DOCUMENT 00 90 00
ADDENDUM

ADDENDUM NO. [2] **Date: February 26, 2020**

RE: **WESTERN TECHNICAL COLLEGE**
APPRENTICESHIP CENTER REMODEL
2860 21ST PLACE SOUTH
LA CROSSE, WISCONSIN 54601
HSR PROJECT NO. 19021

FROM: HSR Associates, Inc
100 Milwaukee Street
La Crosse, WI 54603
(608) 784-1830

Sheet Title:
WALL TYPES

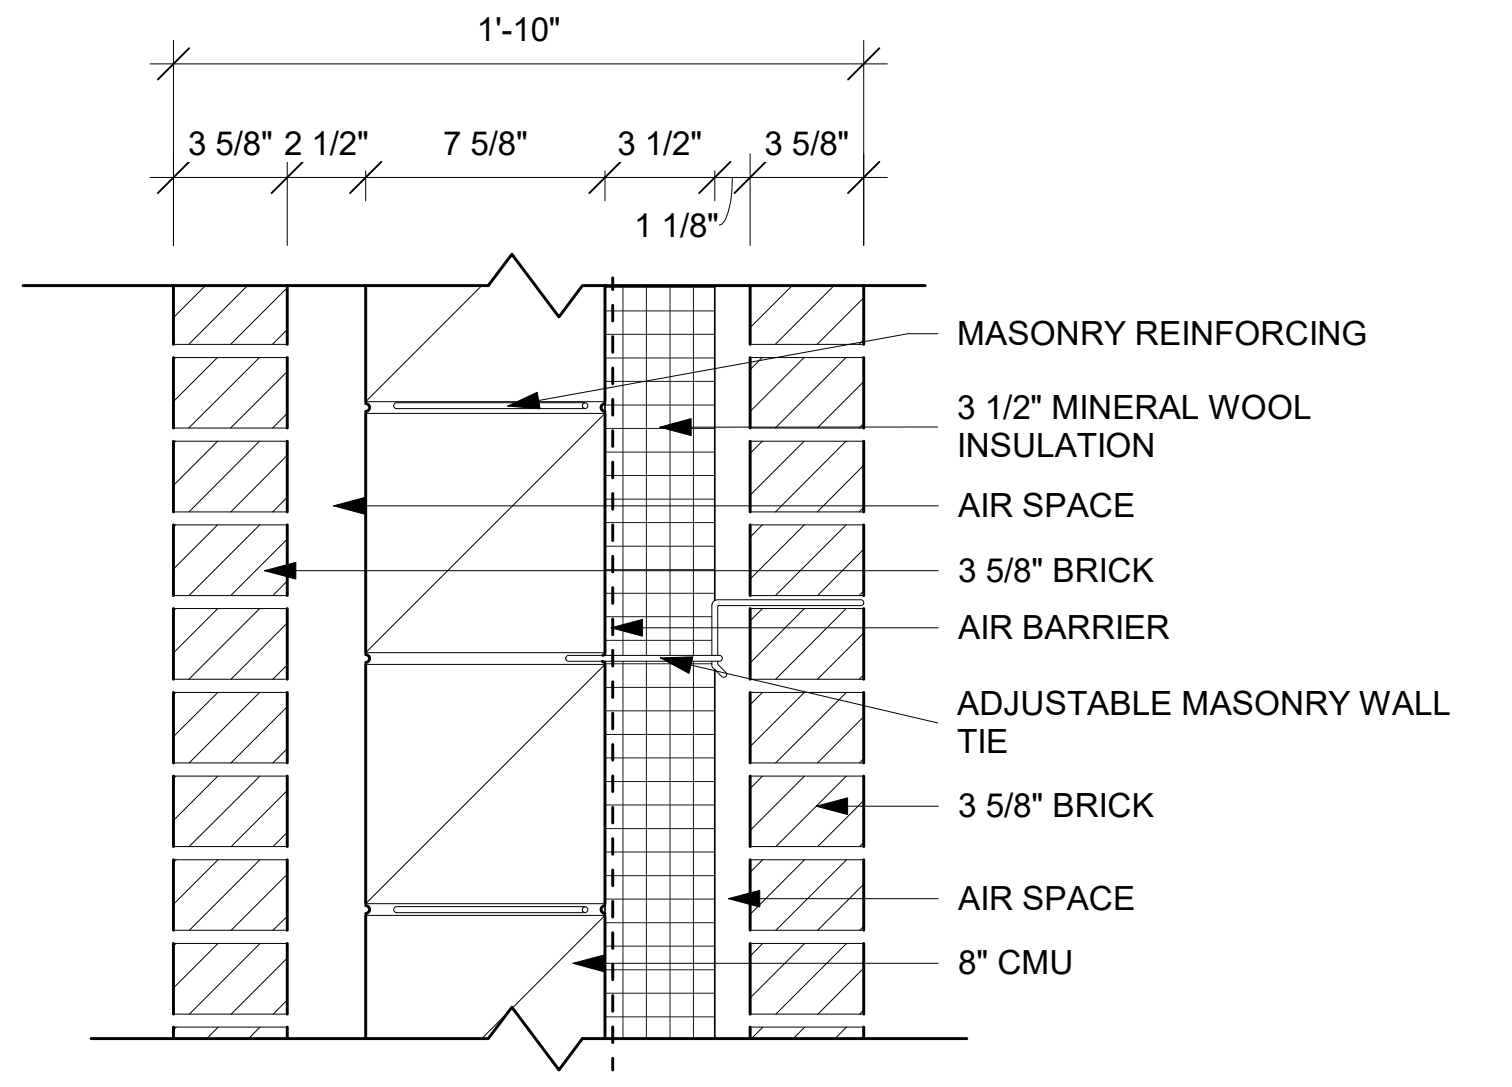
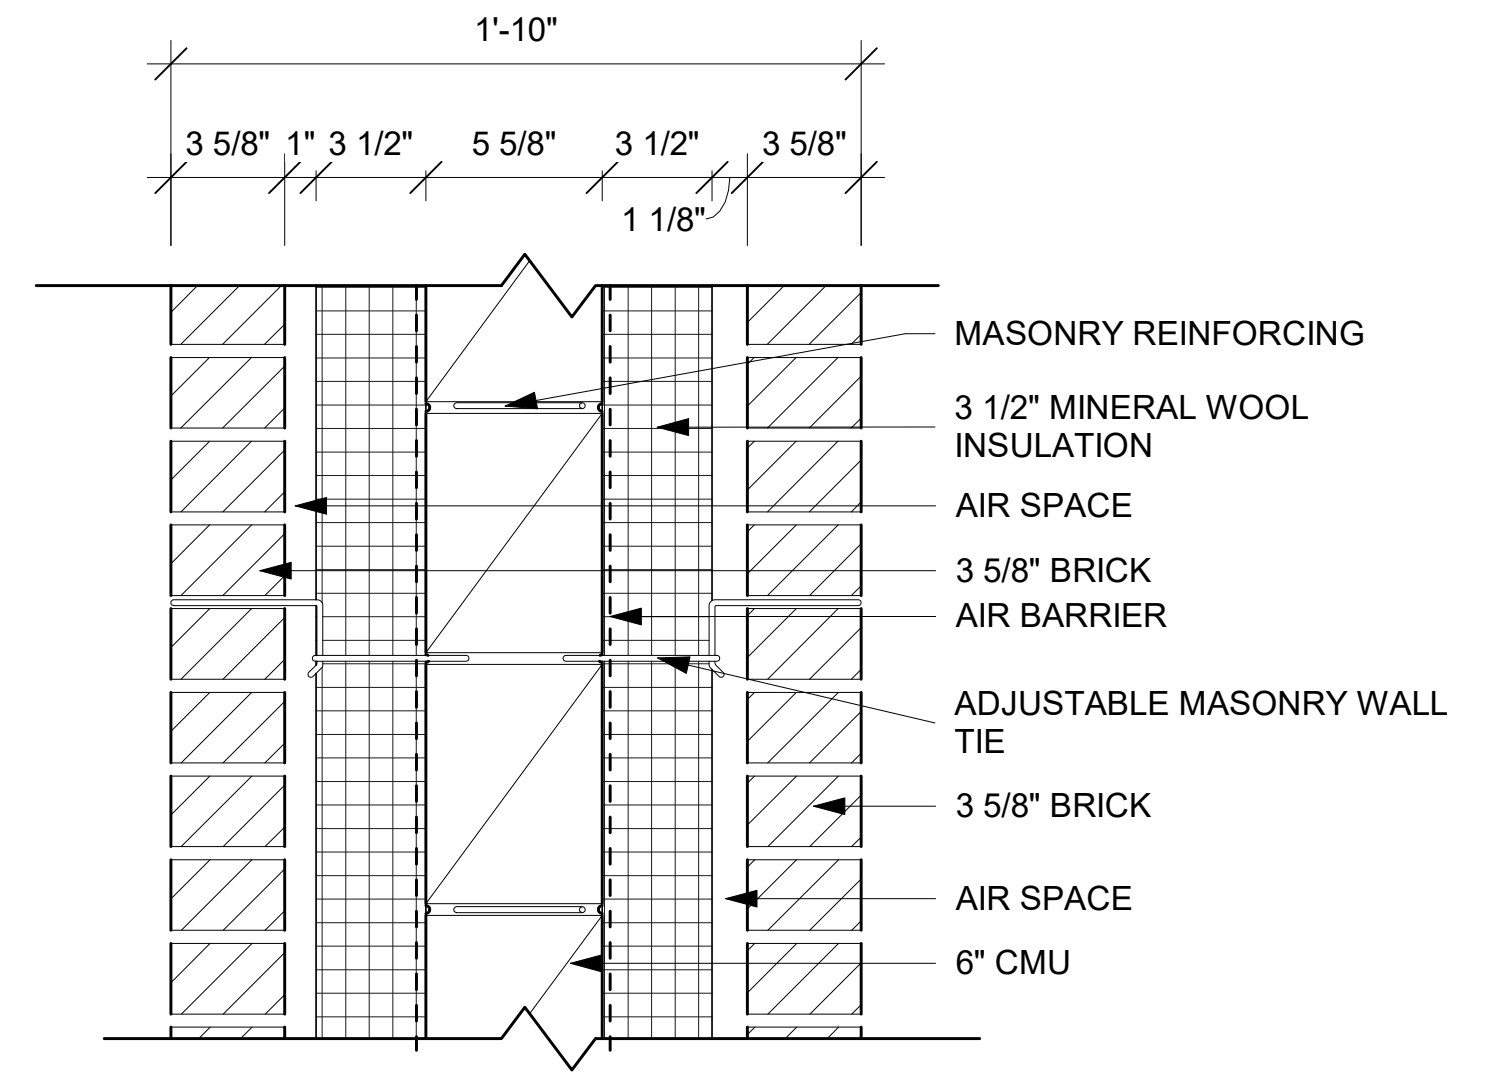
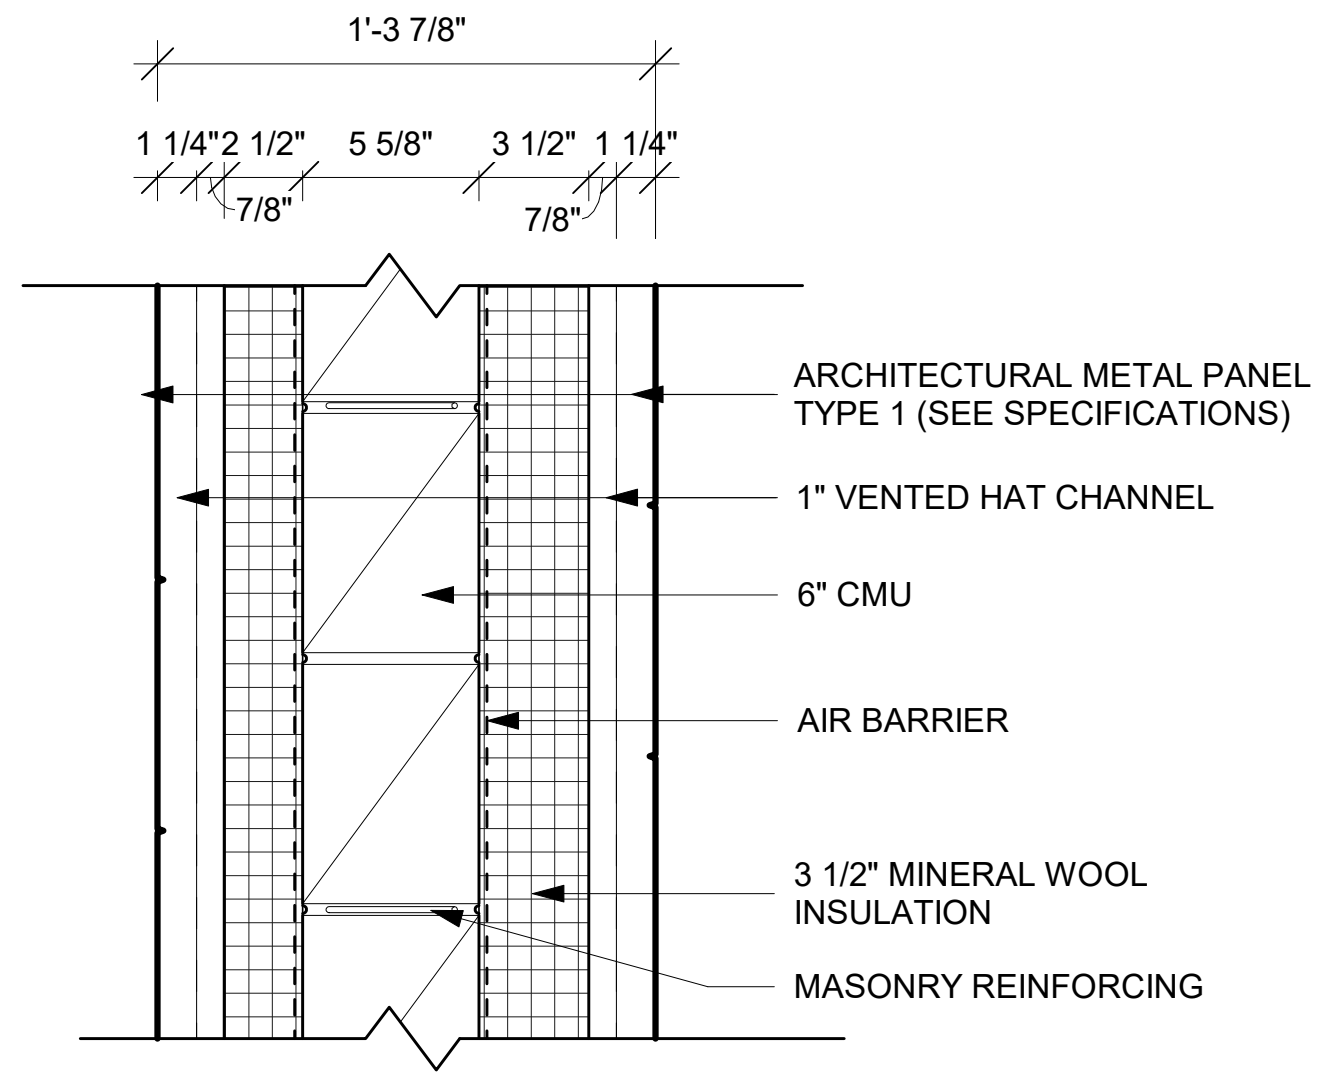
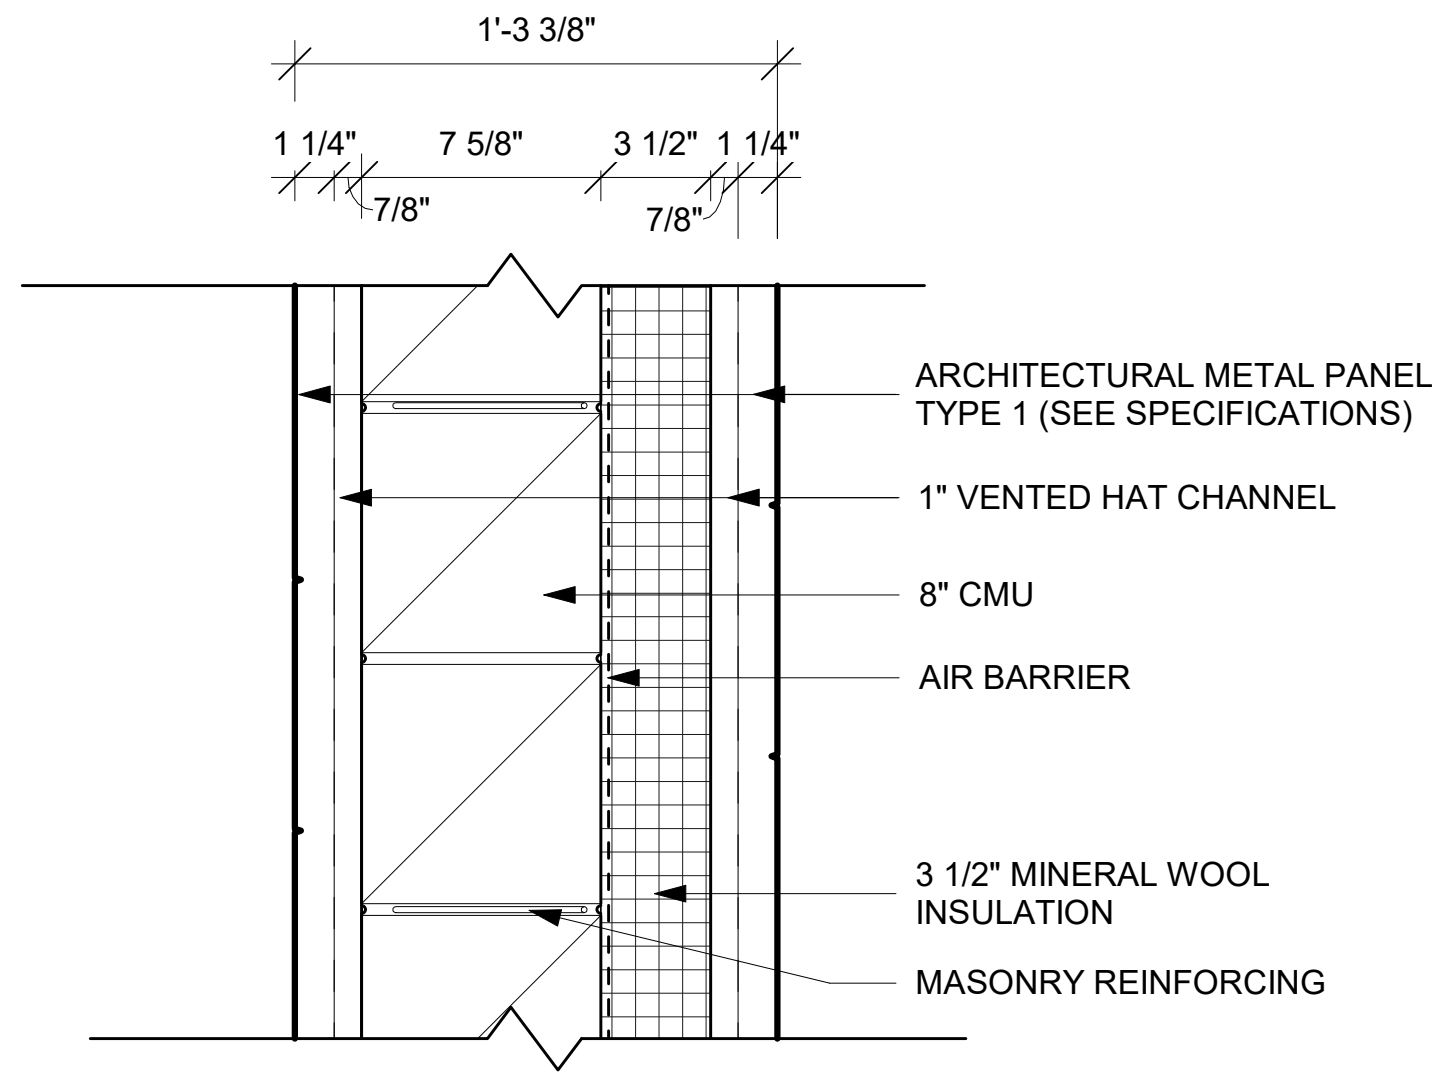
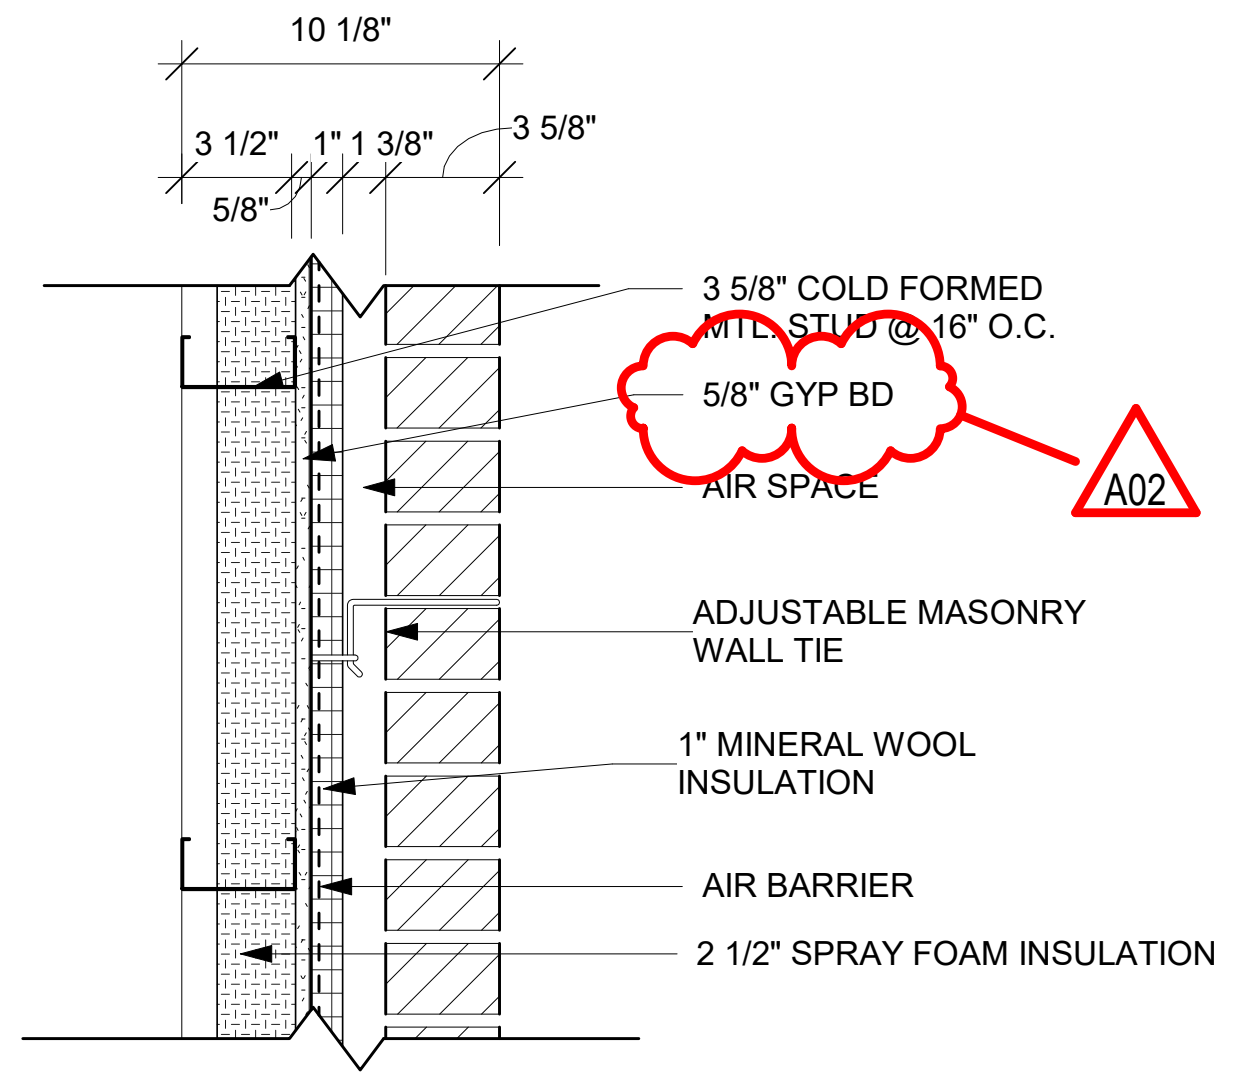
a. Revisions clouded on Drawing.
    b. Exterior gyp sheathing shall be 5/8” in lieu of ½”.
13. Sheet P090 PLUMBING UNDERFLOOR DEMOLITION PLAN 30 x 42 attached hereto

1 PLUMBING UNDERFLOOR DEMOLITION PLAN
1/8" = 1'-0"

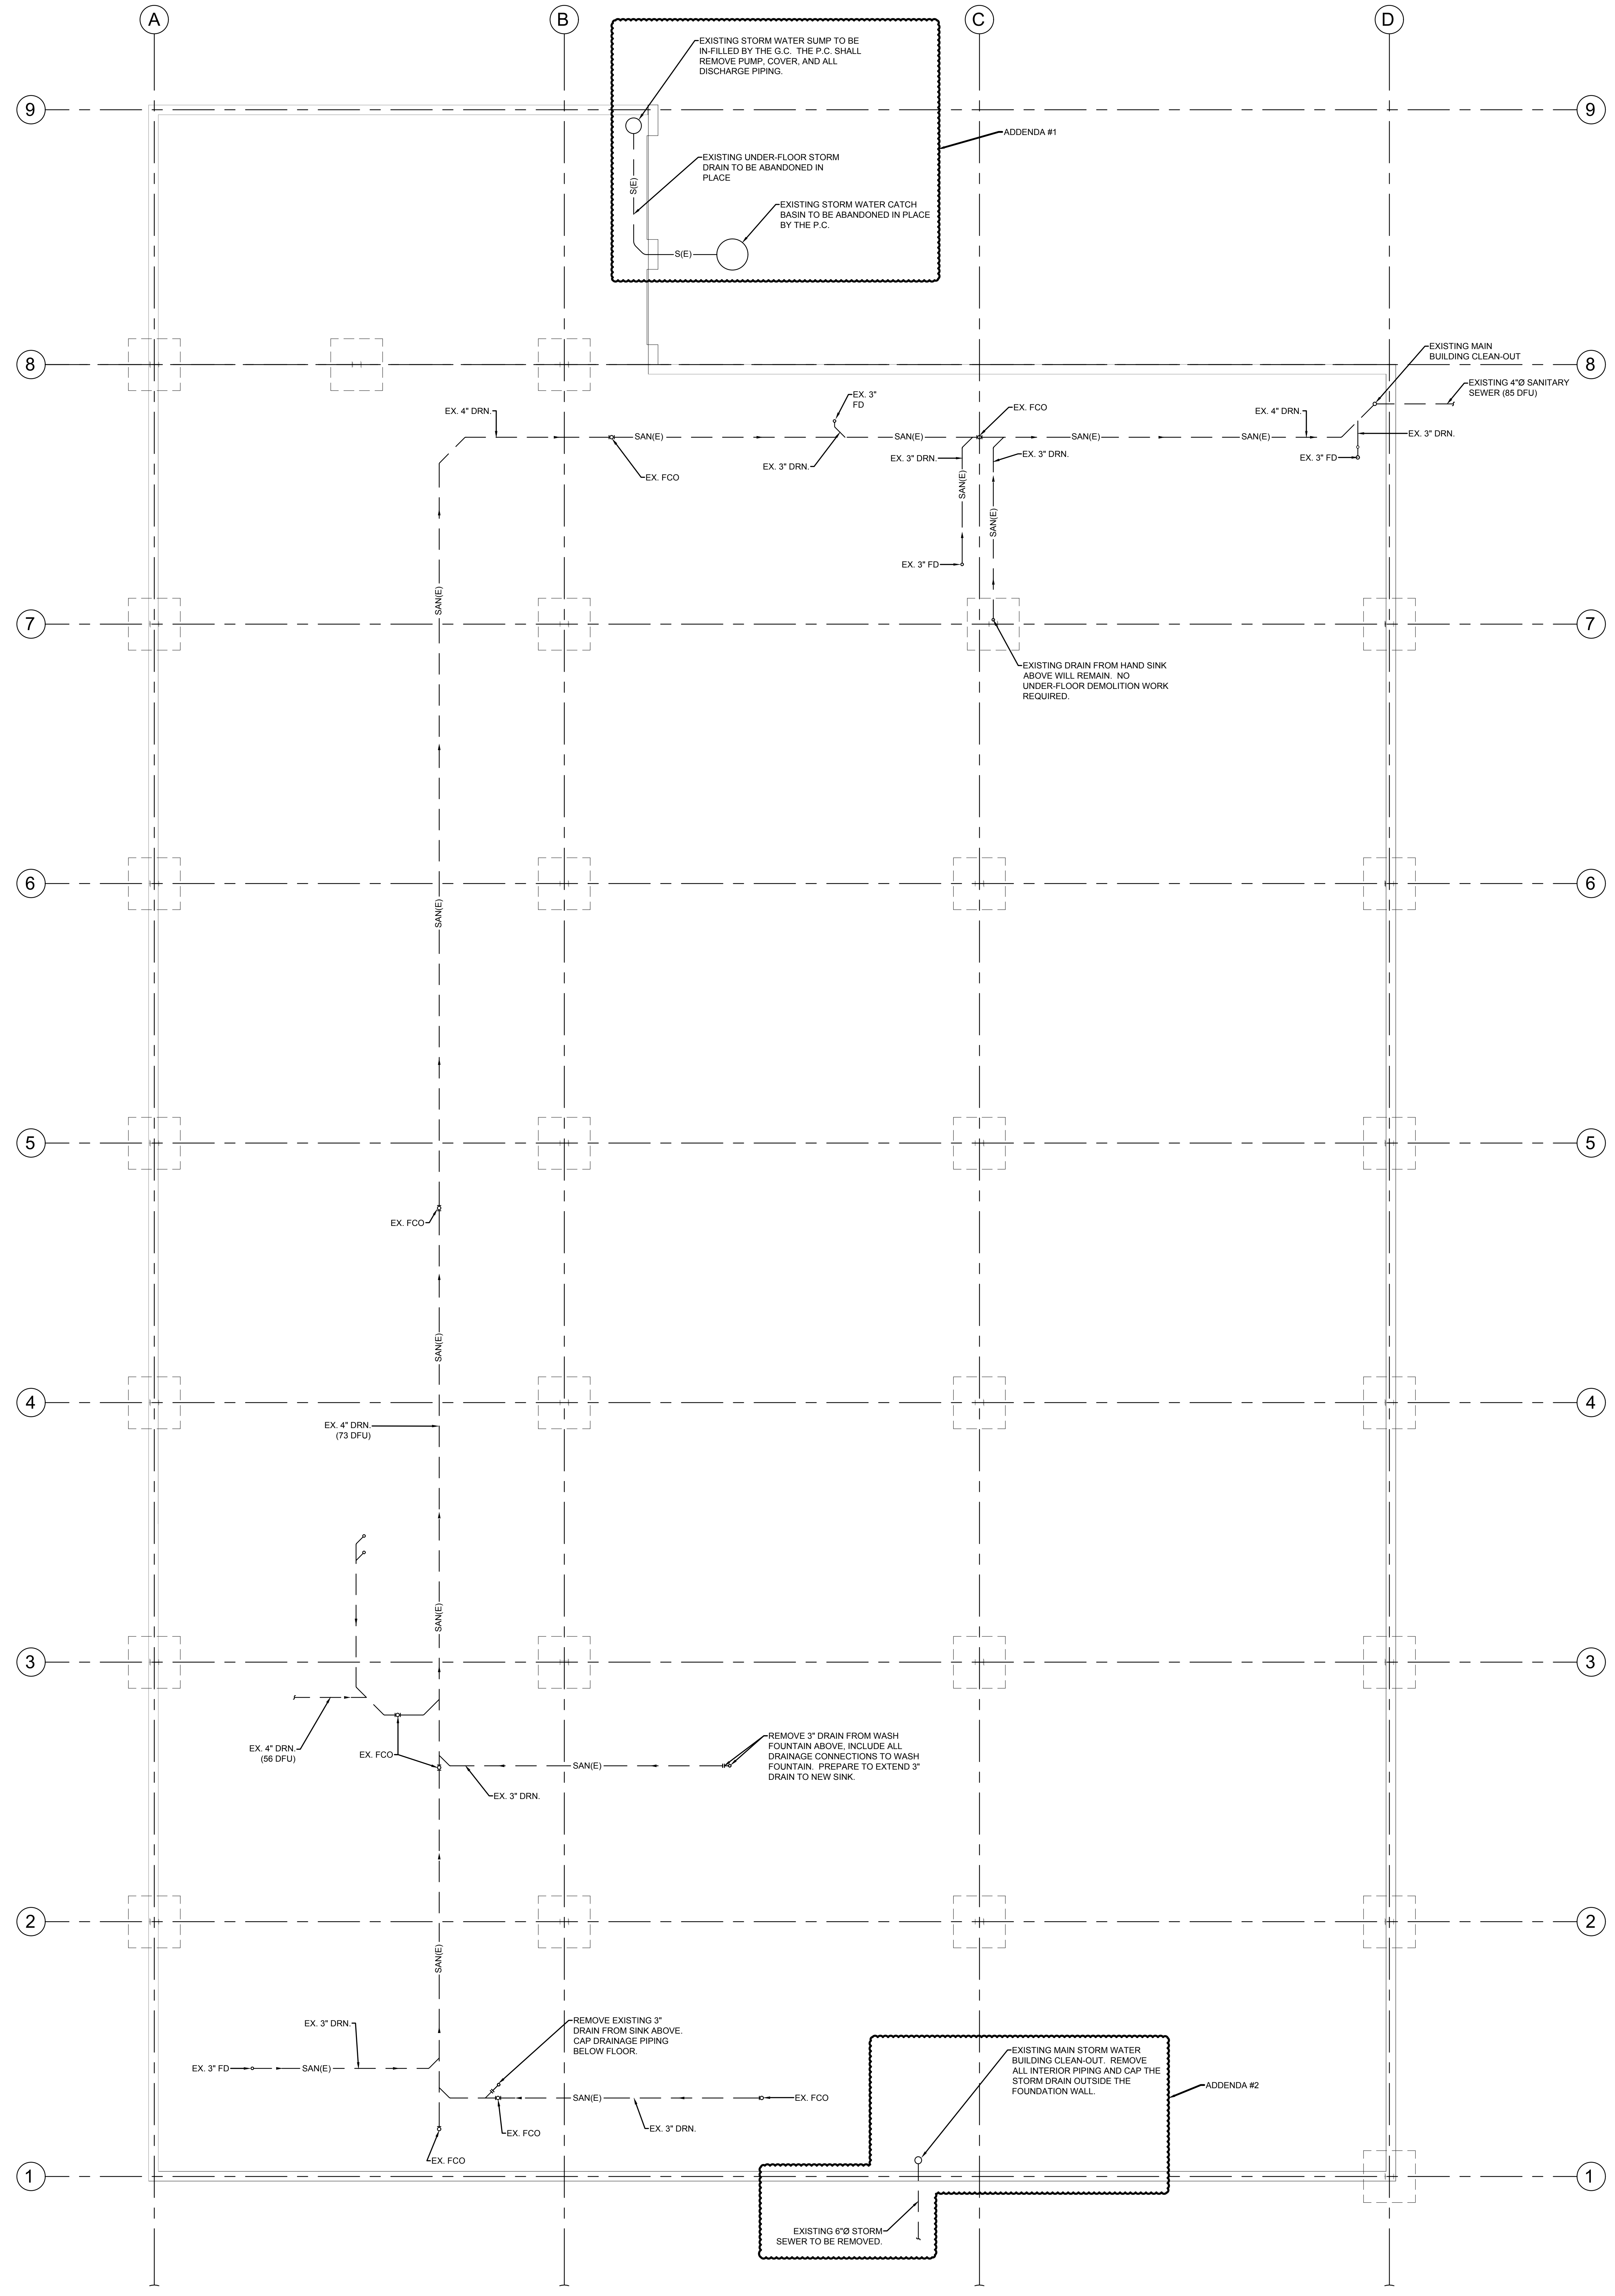
SAN(E)
EX. FCO
EX. FCO
EX. 3" DRN.
EX. FCO
EXISTING MAIN STORM WATER BUILDING CLEAN-OUT. REMOVE ALL INTERIOR PIPING AND CAP THE STORM DRAIN OUTSIDE THE FOUNDATION WALL.
ADDENDA #2
EXISTING 6"Ø STORM SEWER TO BE REMOVED.
